PROJECT Turkevi Center
LOCATION Multi Firs
 821 FIRST AVENUE
 NEW YORK, NY
ARCHITECT PERKINS EASTMAN
 115 5th AVENUE, NEW YORK NY
CONTRACTOR TISHMAN CONSTRUCTION
 100 PARK AVENUE, NEW YORK NY

TITLE: Auditorium
ITEM NO.: 11, 11.01, 11.02, 11.03, 11.04, 11.05, 11.07, 11.08, 11.09, 11.10, 11.11
DESC.: PLAN
DESC.: AUDITORIUM SB1-24, VESTIBULE SB1-20 & SB1-17, WAITING ROOM SB1-22
By: PD **Scale:** As Noted **Job No.:** **Dwg. No.:** 11-01
Status: IN SUBMITTAL REVIEW **Date:** 2019-01-21

D-3 DETAIL OF
SCALE: FULL SCALE
Arch't Ref.: 18/A-652.00

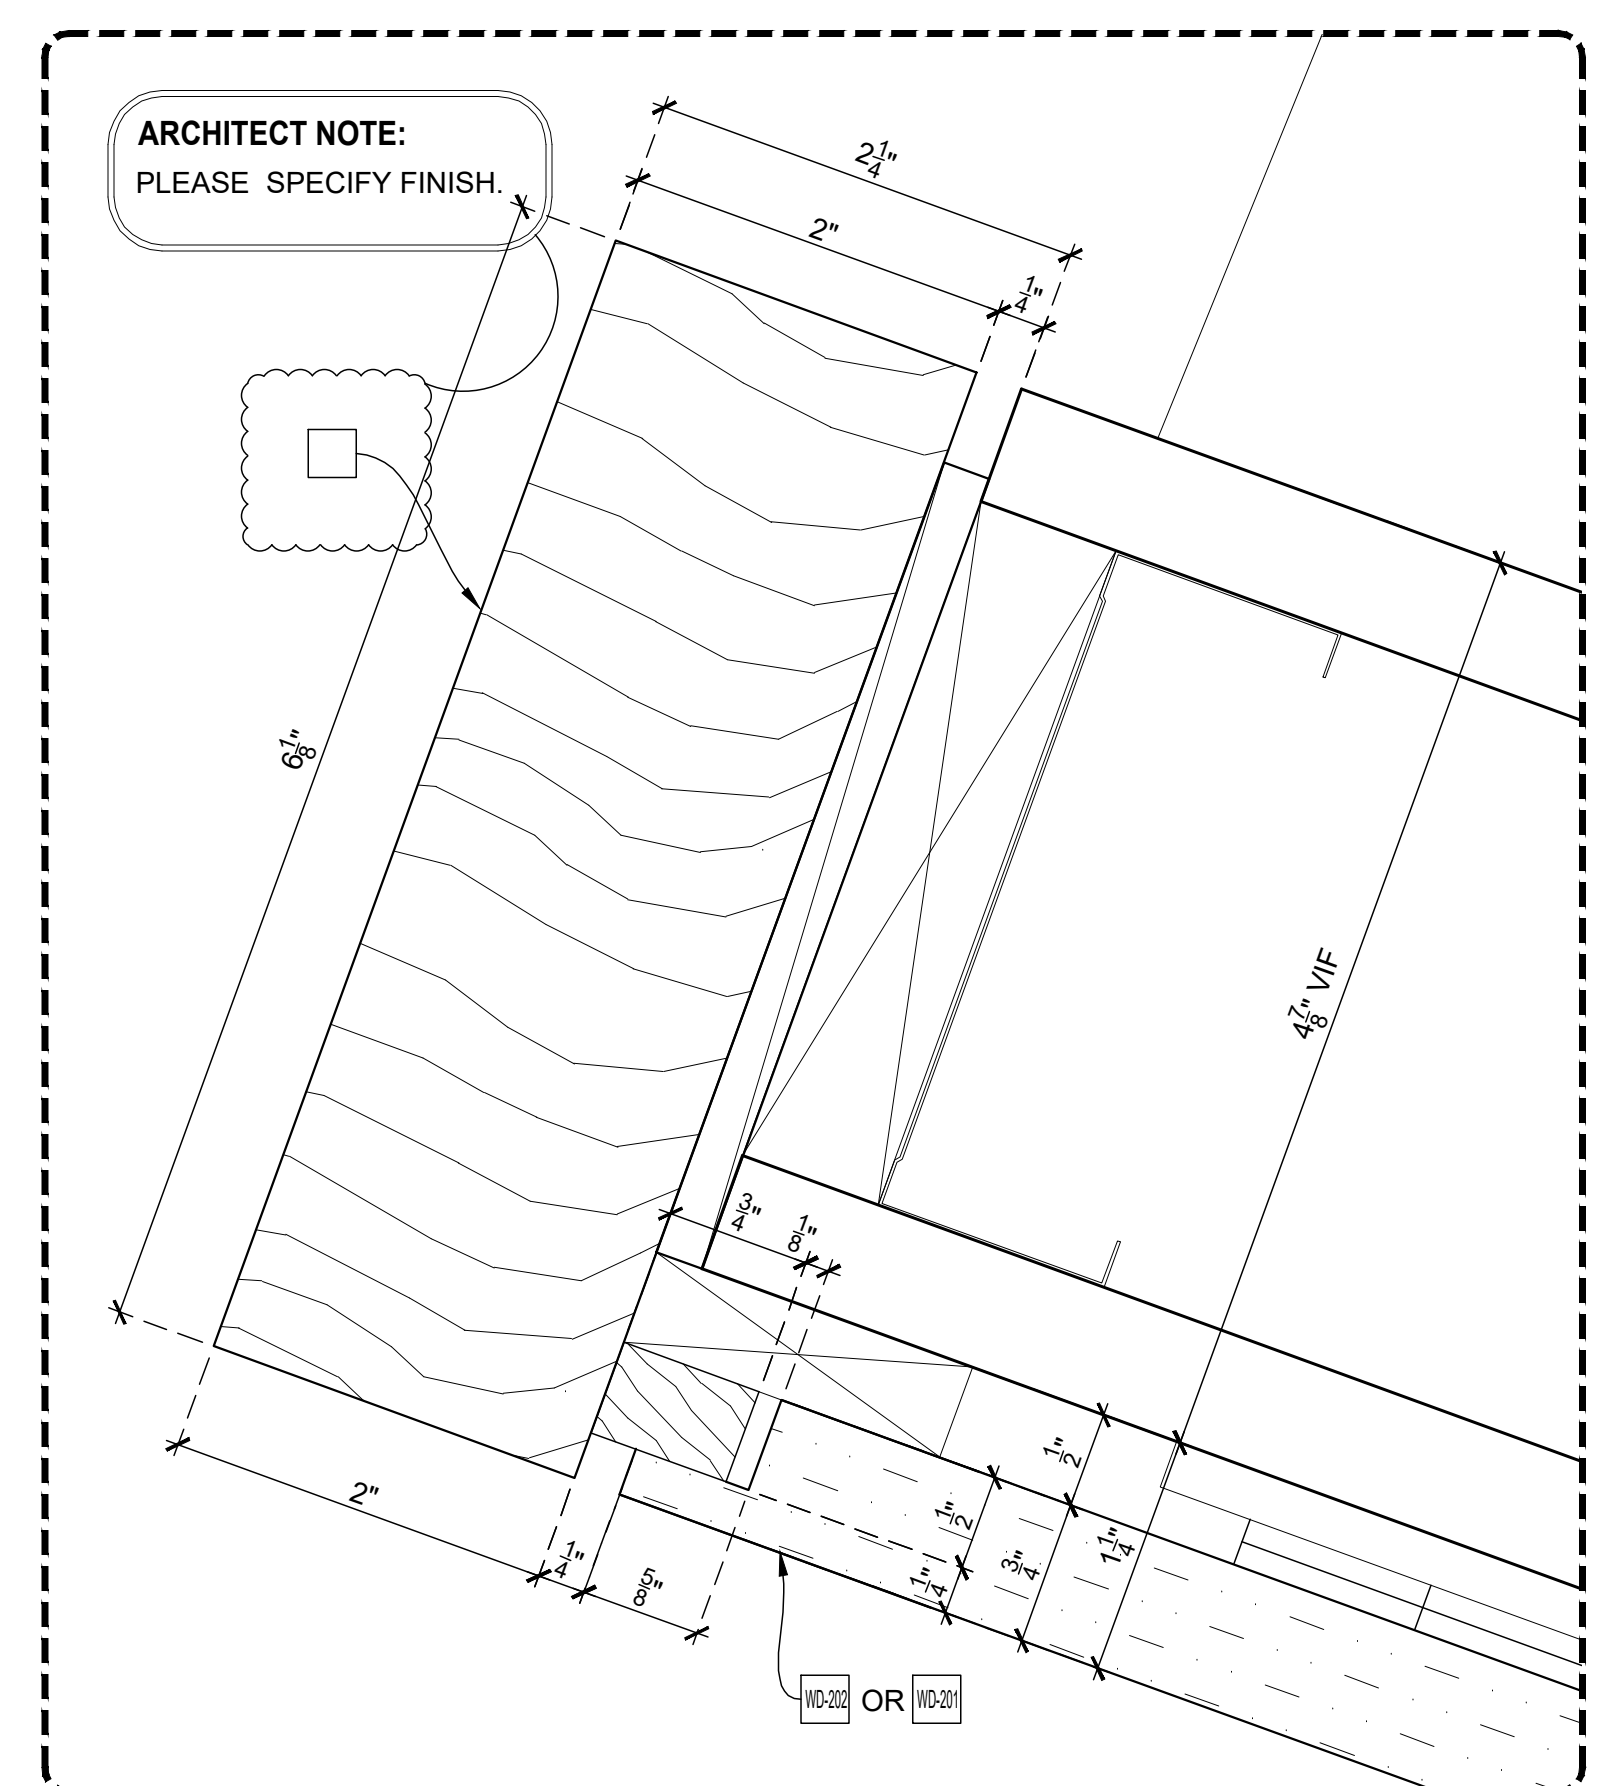
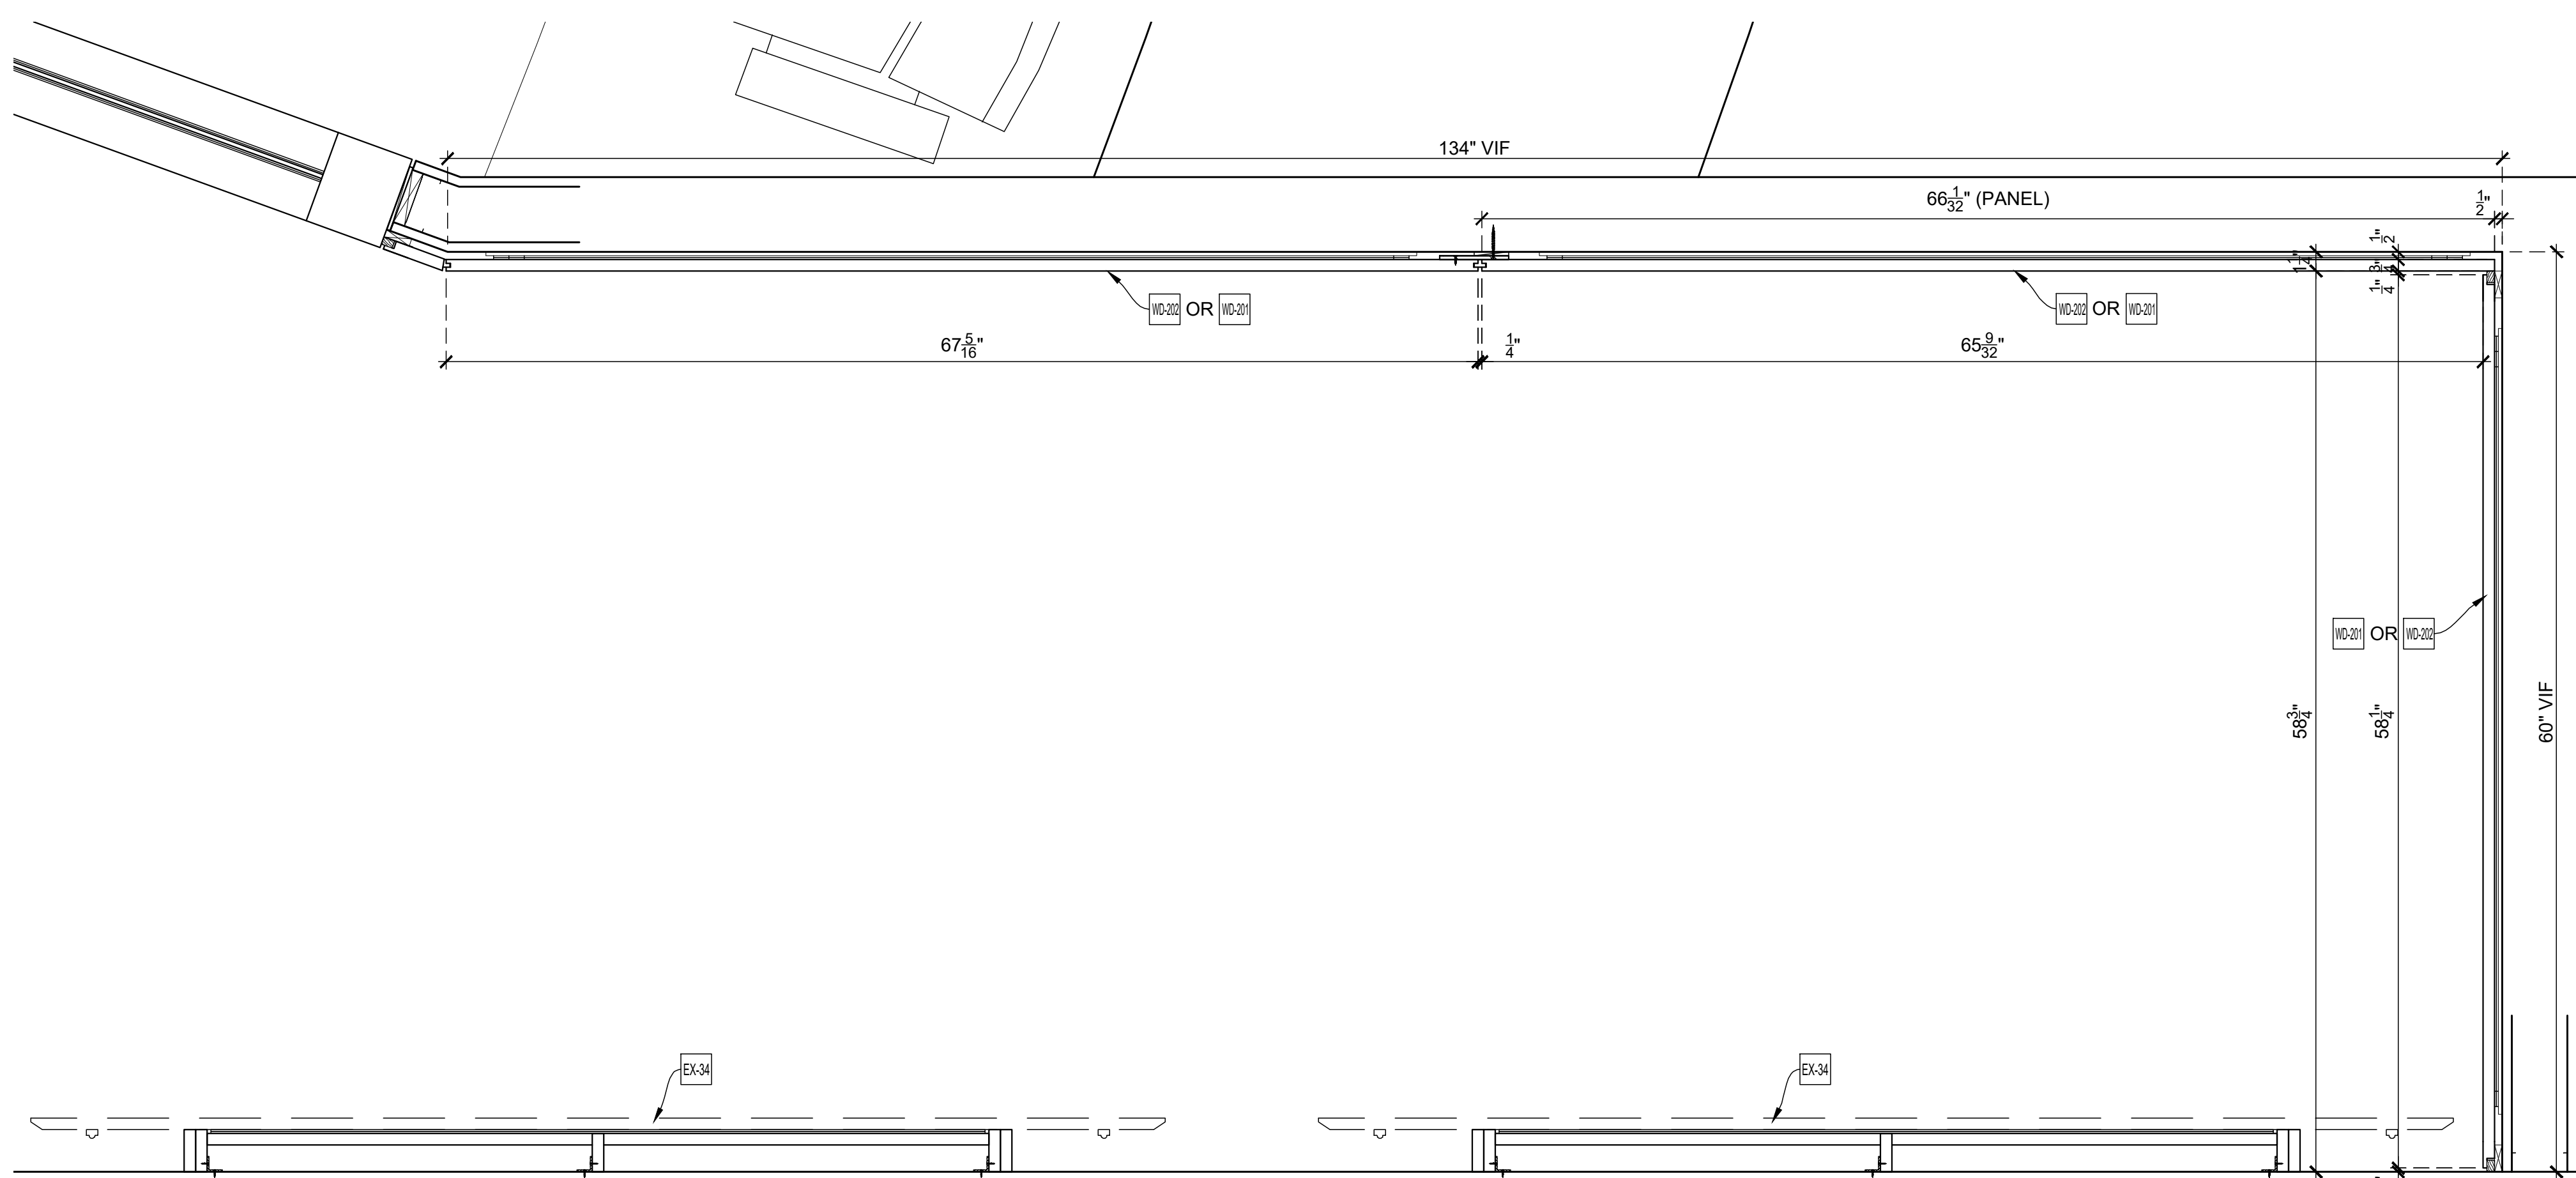
ARCHITECT NOTE:
PLEASE SPECIFY FINISH.

ARCHITECT NOTE:
PLEASE VERIFY SHAPE
OF CORNER GUARD

ARCHITECT NOTE:
PLEASE VERIFY
CONDITION.

By: PD Scale: As Noted Job No. Dwg. No.
Status: IN SUBMITTAL REVIEW Date: 2019-01-21 **11-10**

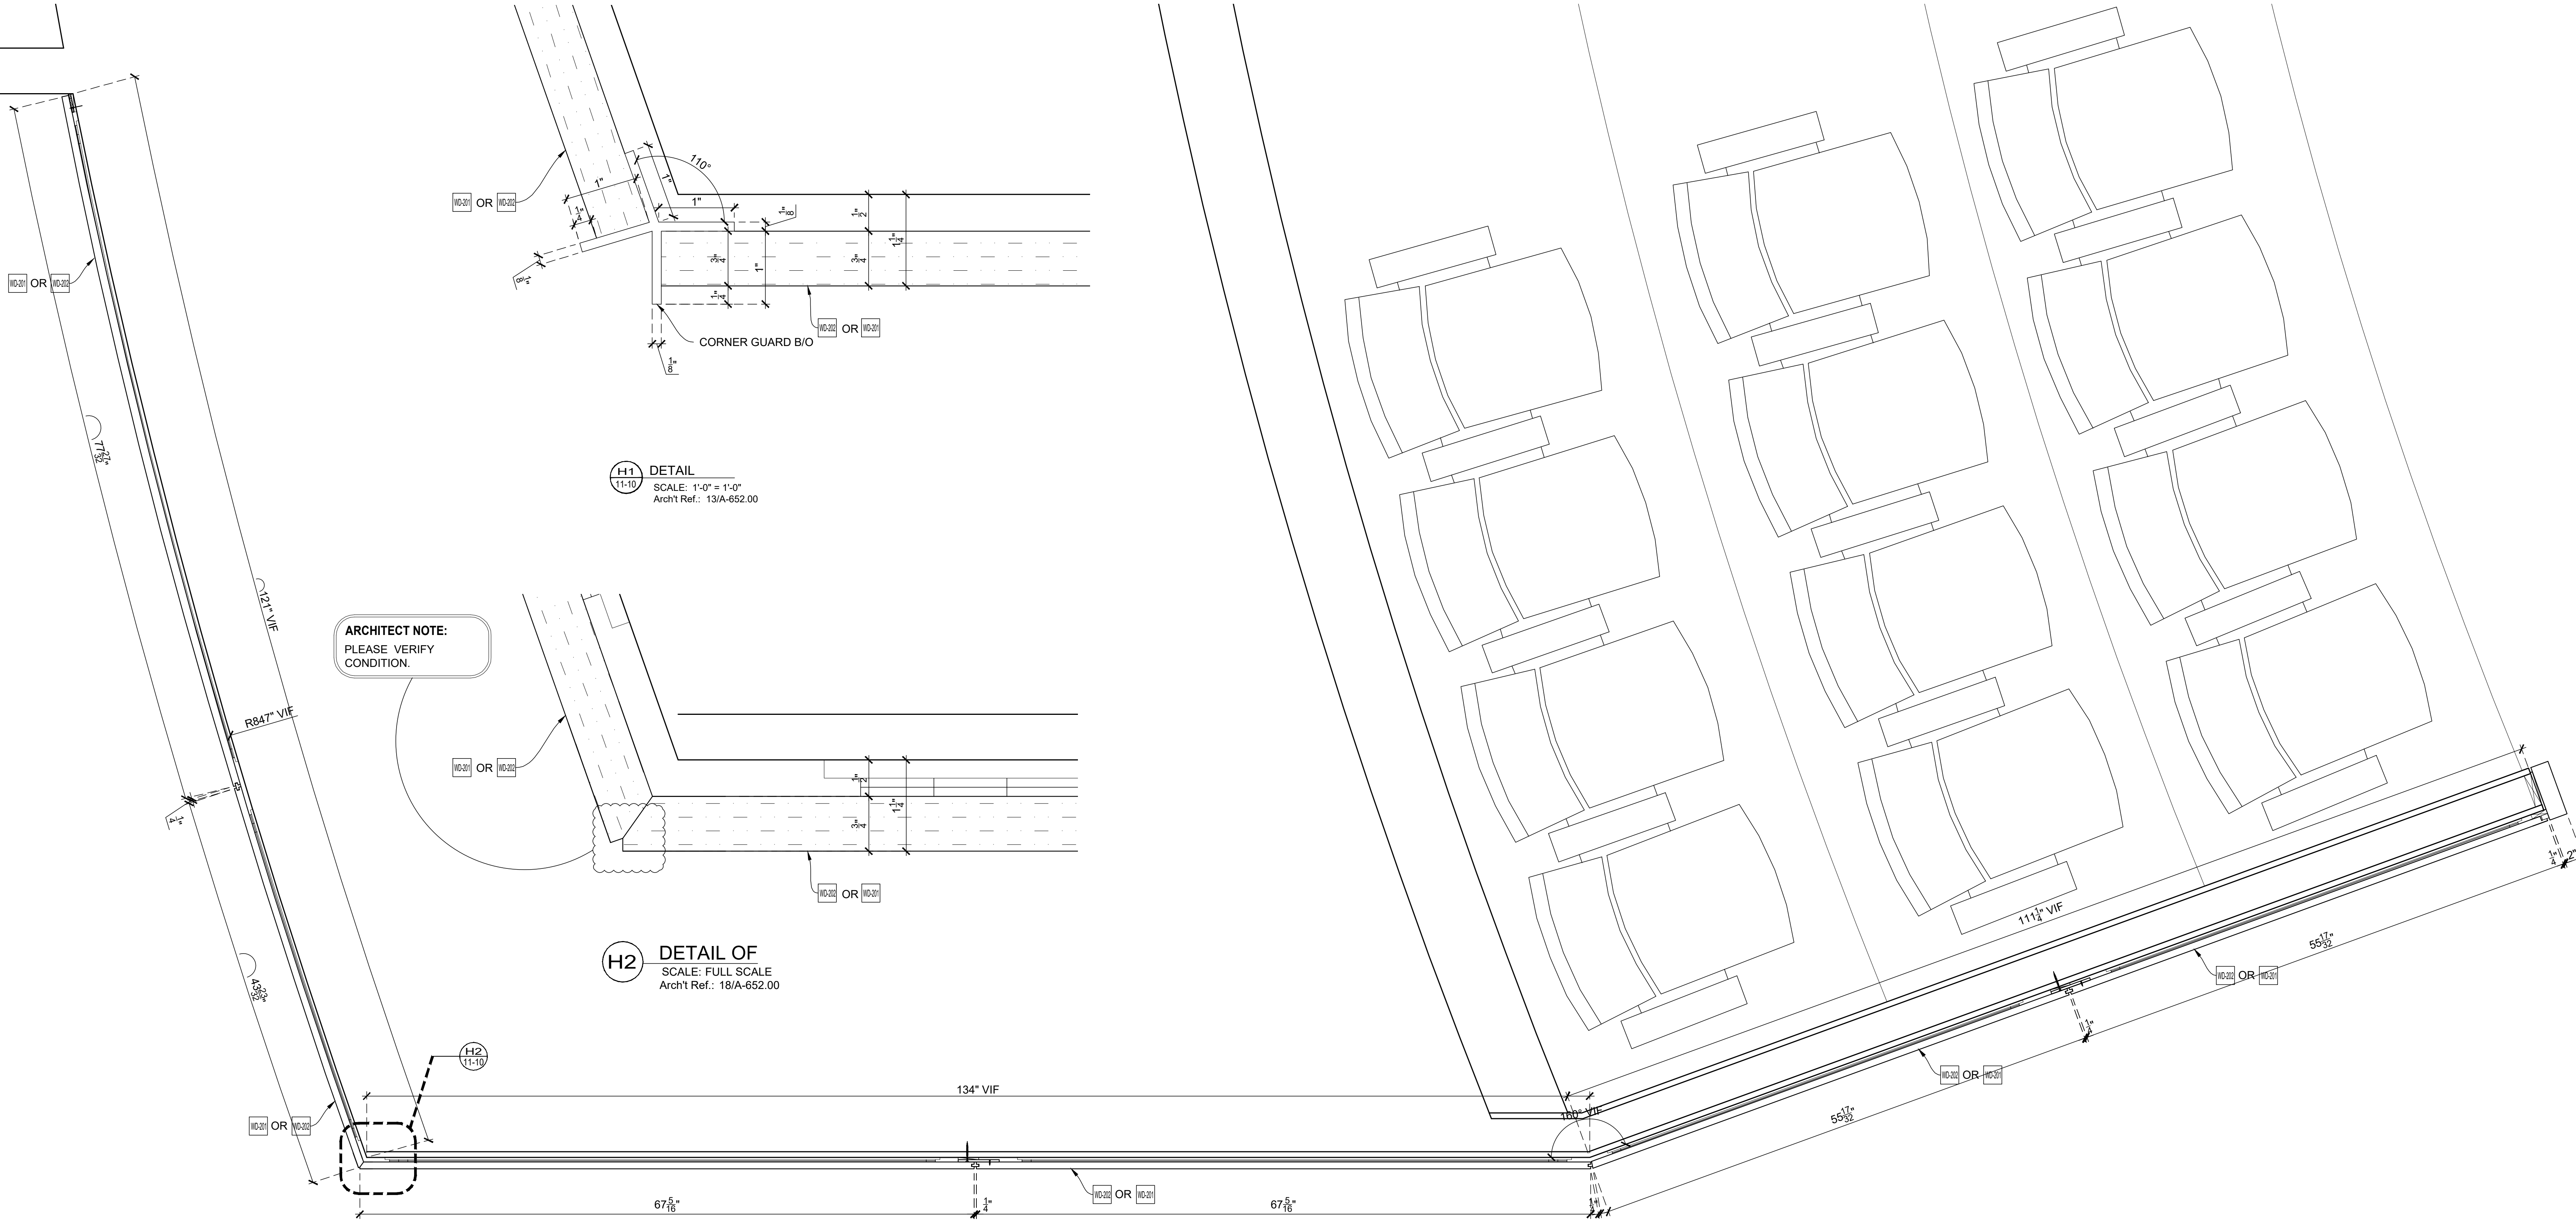
ARCHITECT NOTE:
PLEASE VERIFY
CONDITION.
